DEVELOPMENT REVIEW COMMITTEE (DRC) COMMENT REPORT

PROJECT NAME: Towers Retirement Home, Incorporated

CASE NUMBER: PDD19002

REQUEST: Site Plan Level IV Review: Rezoning from Residential Multifamily Mid Rise/Medium High Density (RMM-25) District to Planned Development District (PDD) with Site Plan Approval for 39 Multifamily Residential Units

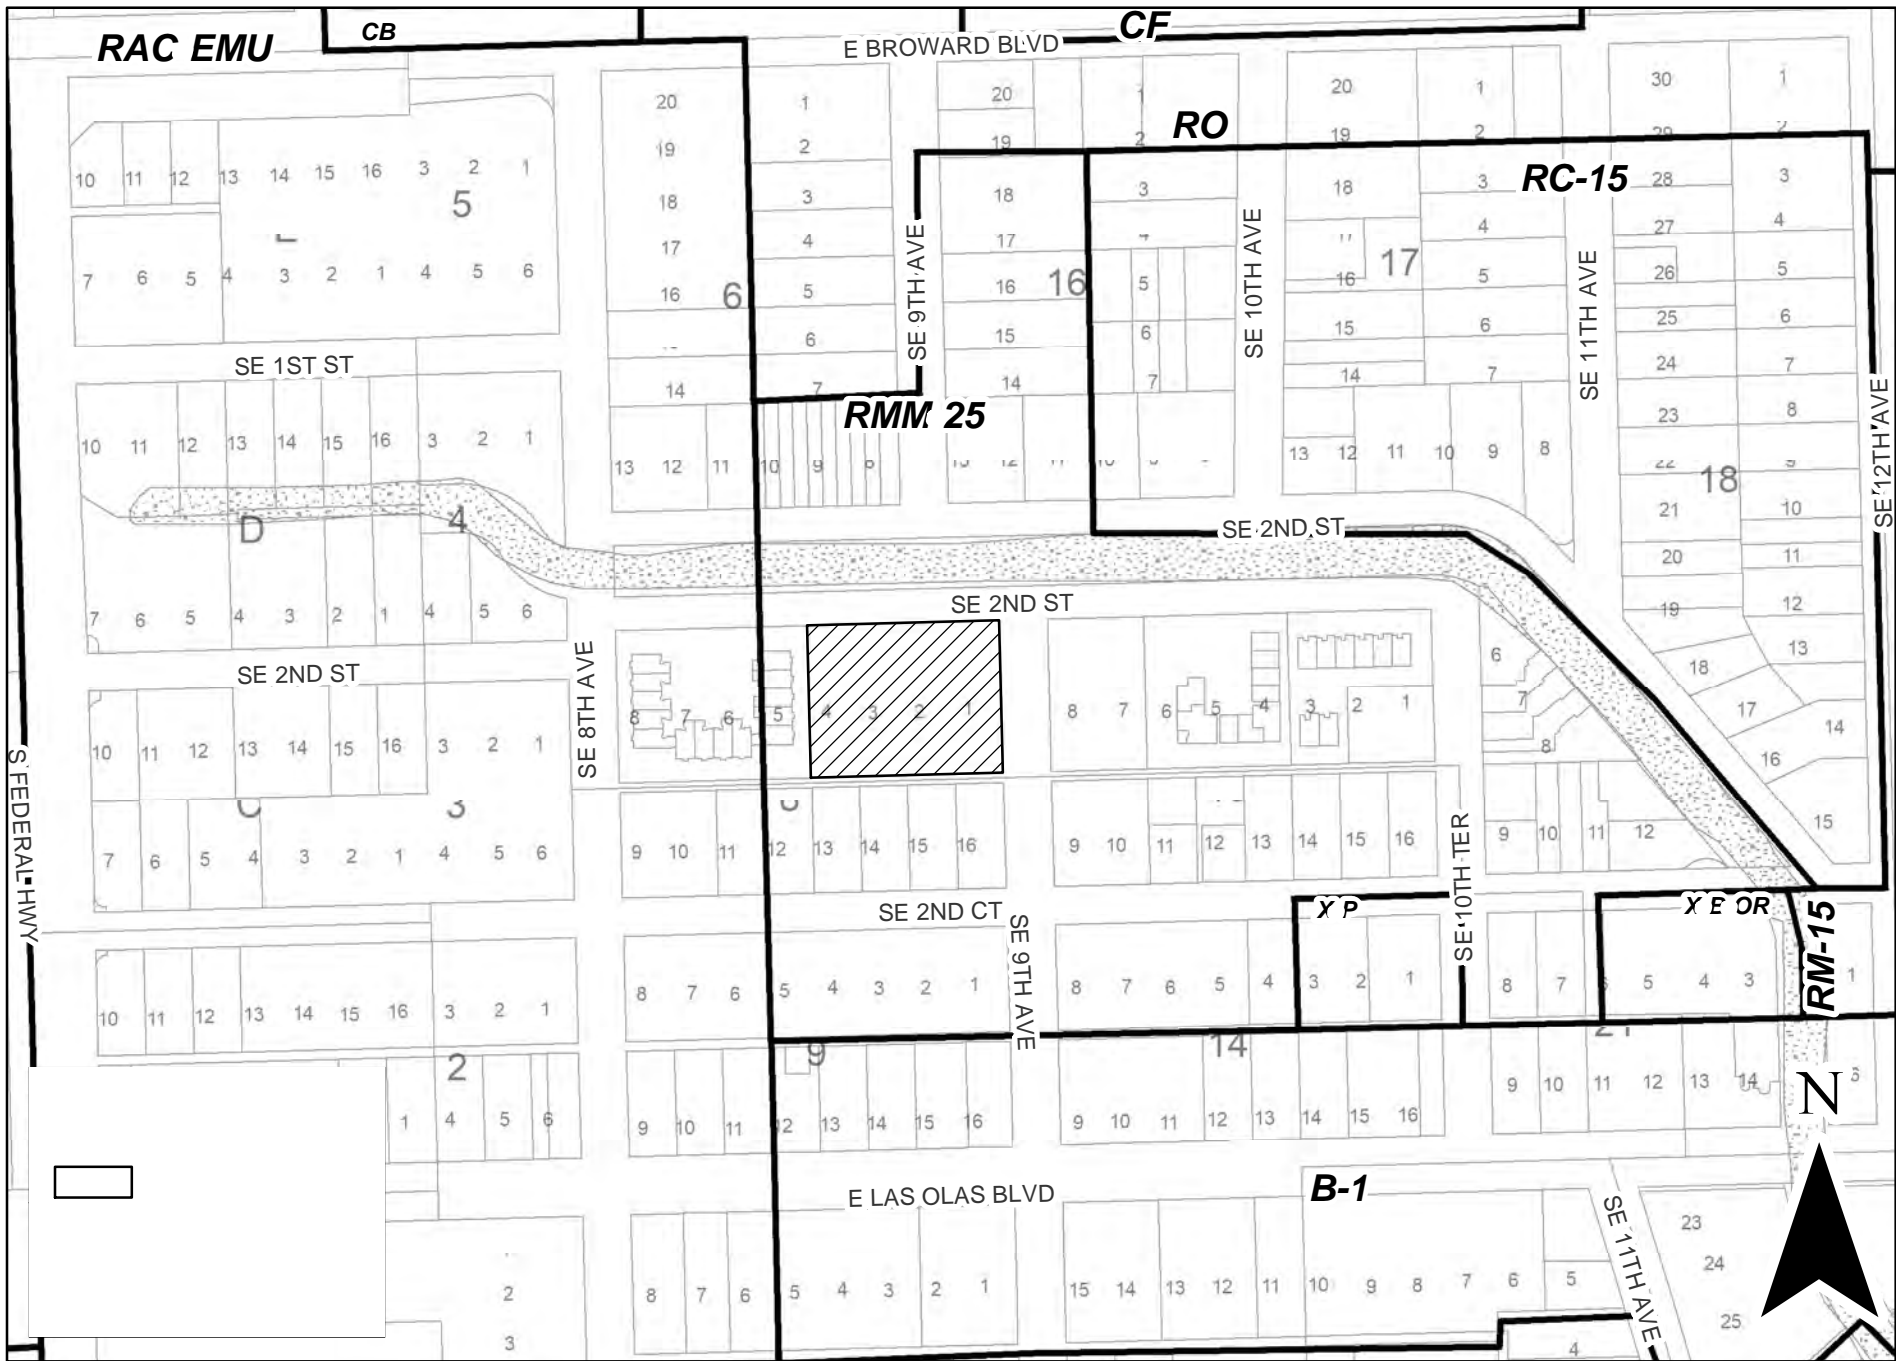
23. At the main entrance on the north elevation along SE 2nd Street, older photos suggest that a more decorative column was used such as a Corinthian column. This type of column can also be seen as a support for the entrance of Saint Anthony Catholic School which was designed by the same architect, Francis Abreu, and was constructed at the same time. Additional designs shown in the architect's monograph, provided in the historic designation application, also show this type of column used in residential projects that were also constructed at the same time period. Throughout the remainder of the proposed project, specifically in locations where columns are to be inserted as part of the new construction, a more simplified column is more appropriate, including at the new entry canopy on SE 9th Avenue. Please note on the south elevation drawing, Sheet A-4.0, it appears that there is an additional column that is shown but does not appear to provide any support.

24. At the main entrance on the north elevation along SE 2nd Street, windows flanking the front entry door appear to be storefront style windows however historic photos suggest that these were floor to ceiling doors with a fan light above. Physical investigation of these openings from the interior should be conducted to provide additional information on the size of the original openings. From the results of this investigation, windows or doors that are appropriate to the style should be utilized.
